W3F1-2004-0086

SUBJECT: Supplement to Amendment Request NPF-38-249,
Extended Power Uprate
Waterford Steam Electric Station, Unit 3
Docket No. 50-382
License No. NPF-38

Response to Request for Additional Information

Figure B-7 RCS Loop Temperature Deviation for Full Load MSLB Transient

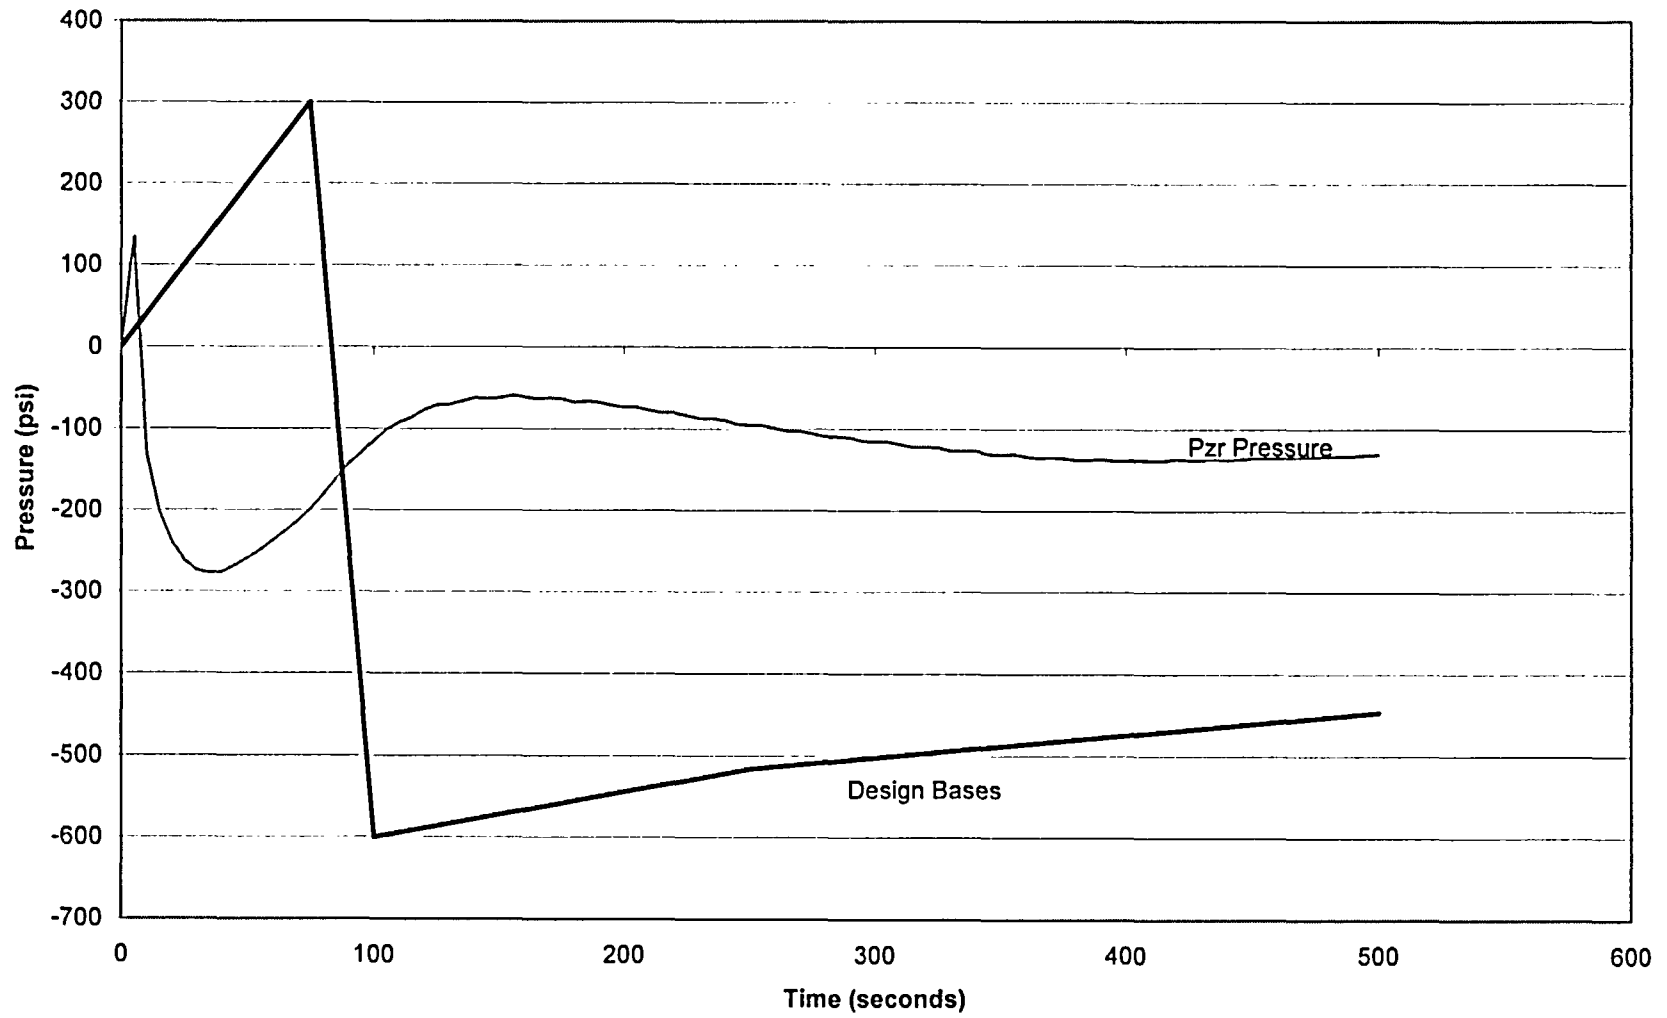
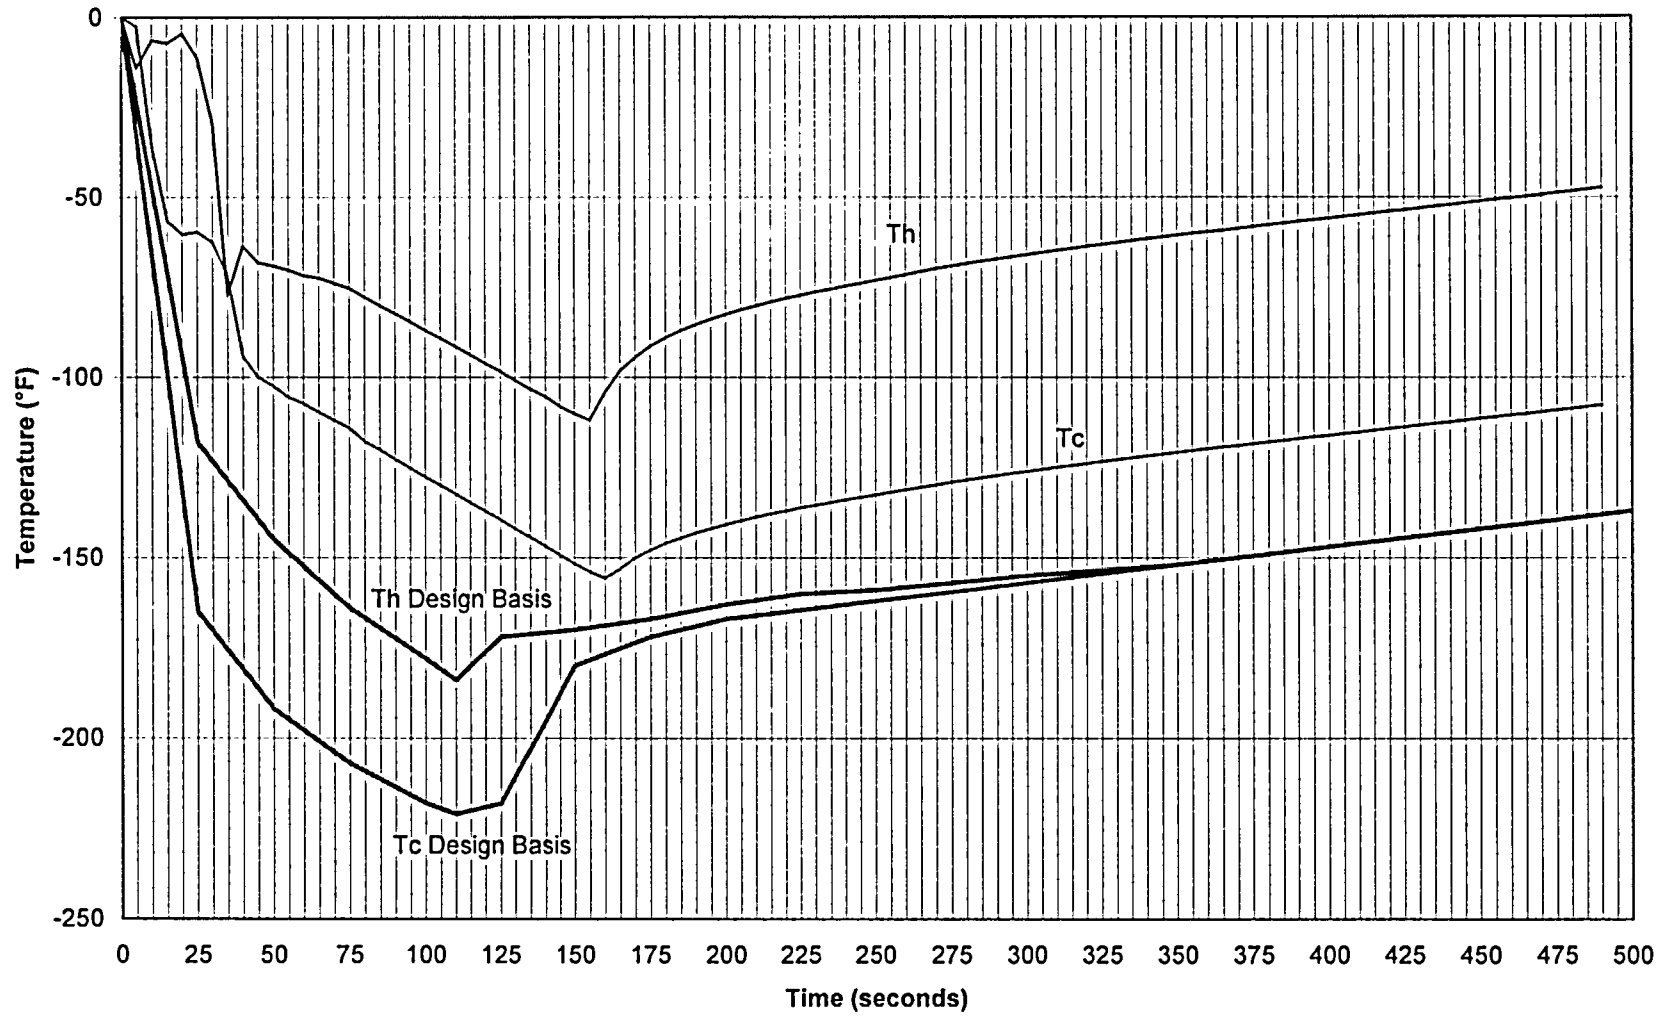
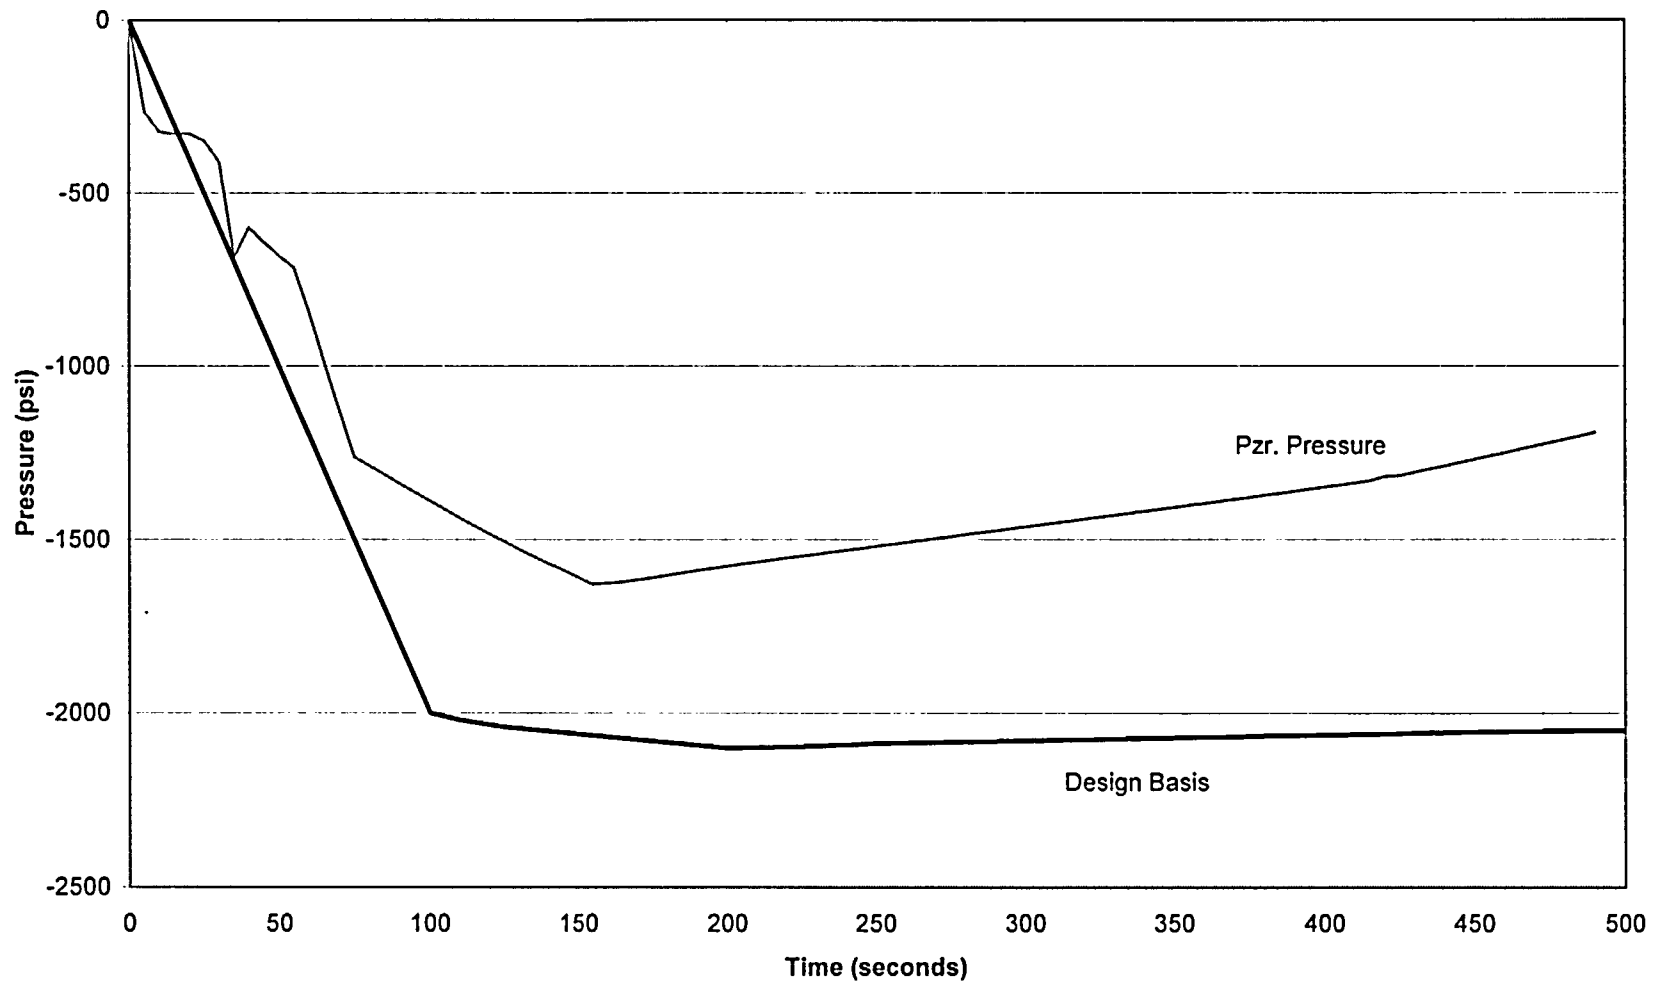
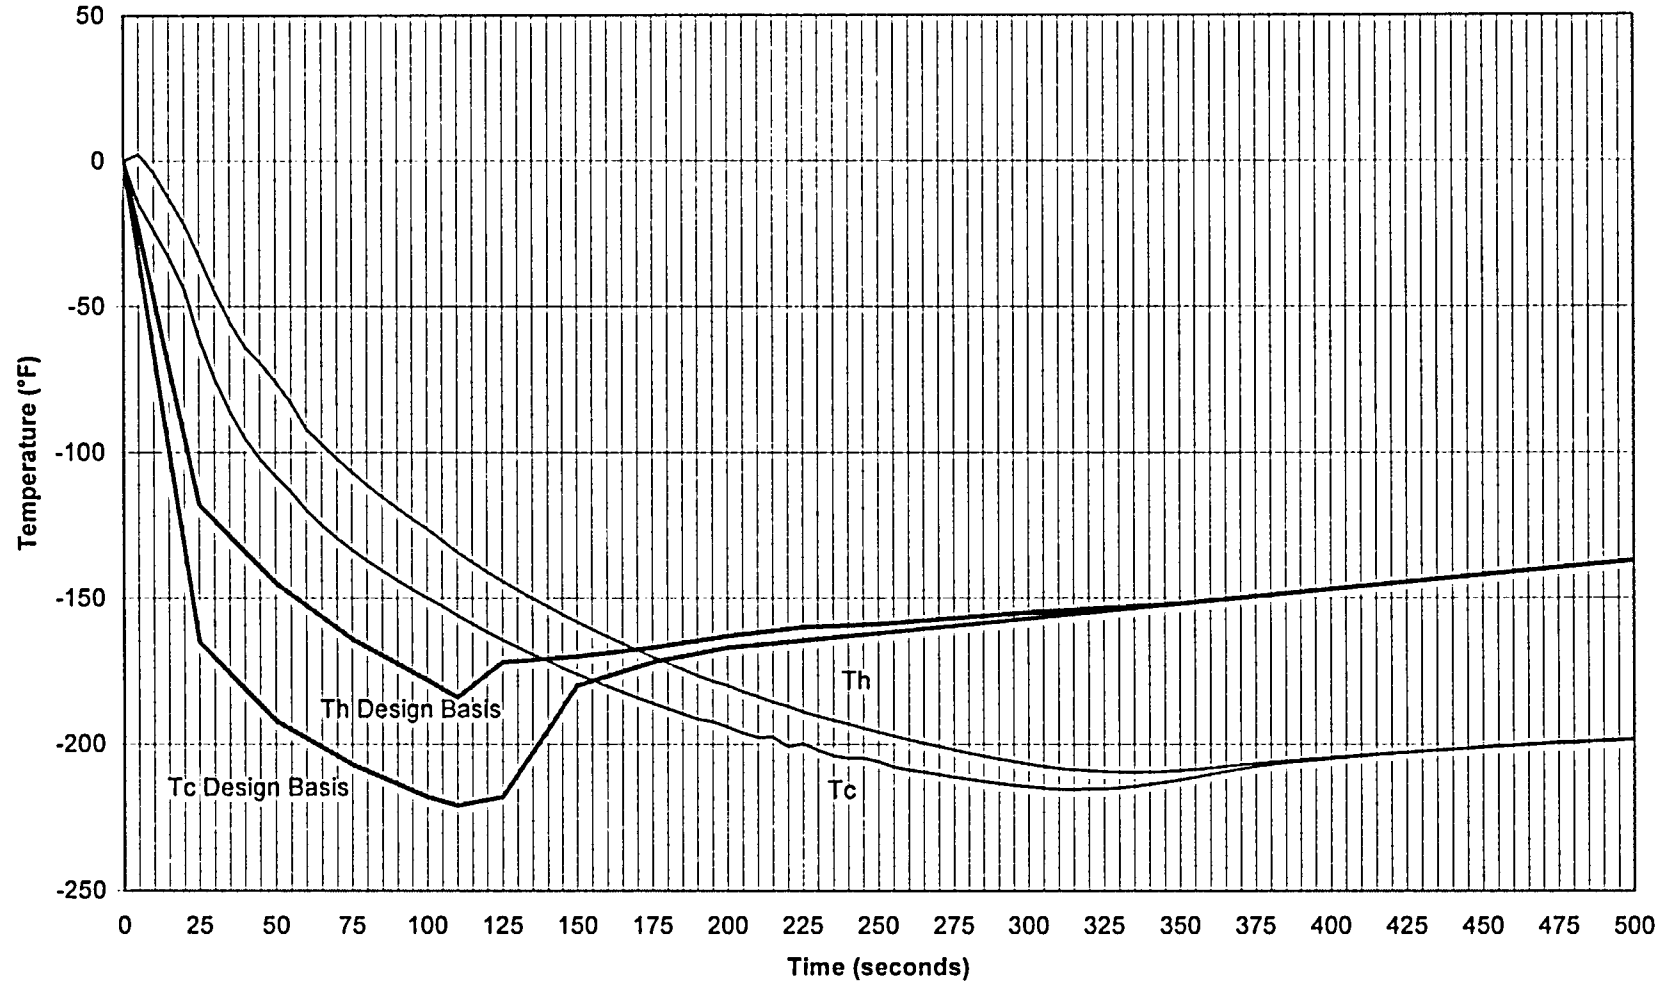
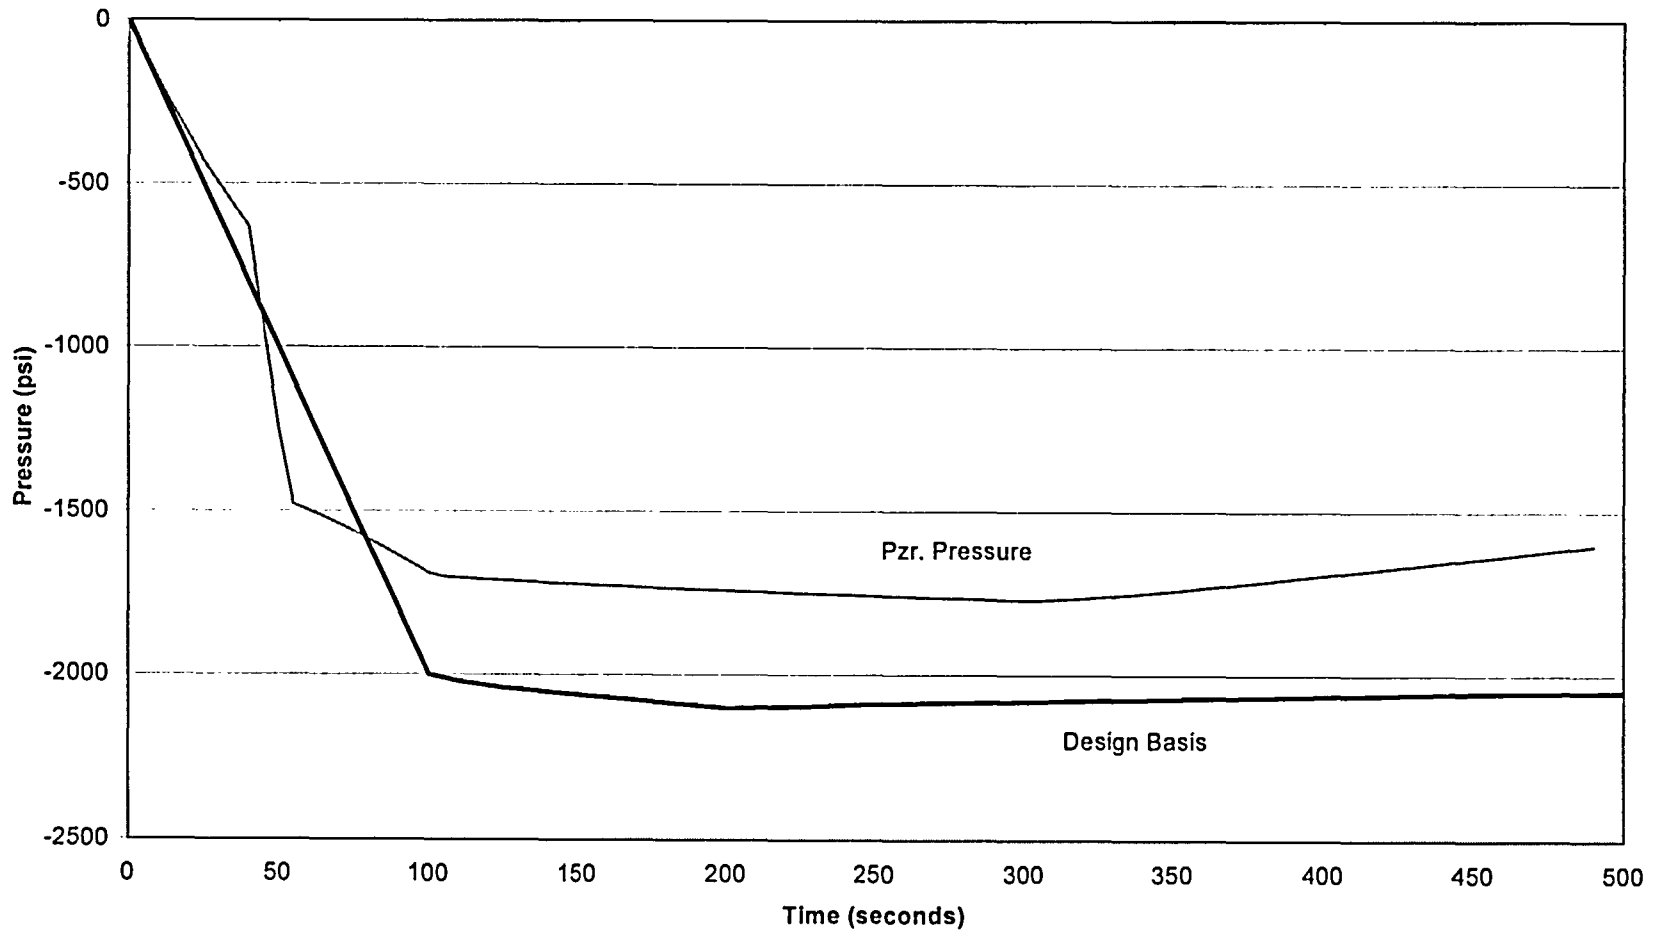
In Section 2.2.2.1.1, you indicated that power uprate resulted in minor changes to as-calculated normal operation transients, and a detailed evaluation of the changes in stresses and fatigue levels in the Reactor Coolant System (RCS) due to these transients was performed to demonstrate that the originally specified design transients for Waterford 3 remain applicable under Extended Power Uprate (EPU) conditions. This was accomplished by demonstrating that transients affected by EPU have no significant effect on the stresses or cumulative usage factors (CUFs) of the limiting RCS components. Provide a comparison of transients at the power uprate conditions to the original design-basis transients with respect to the number of occurrences and changes in pressure and temperature in the stress and cumulative fatigue usage calculations.

The originally specified design transients were evaluated for the potential effect EPU would have on them. The same list of events and number of event cycles were maintained for the EPU design transient evaluation. The Reactor Trip, Loss of Load, Loss of Flow and Loss of Secondary Pressure events were rerun using EPU conditions. The plots for the rerun cases are attached. The rerun cases and results of the evaluation were documented and evaluated for any effects on stress and fatigue levels.
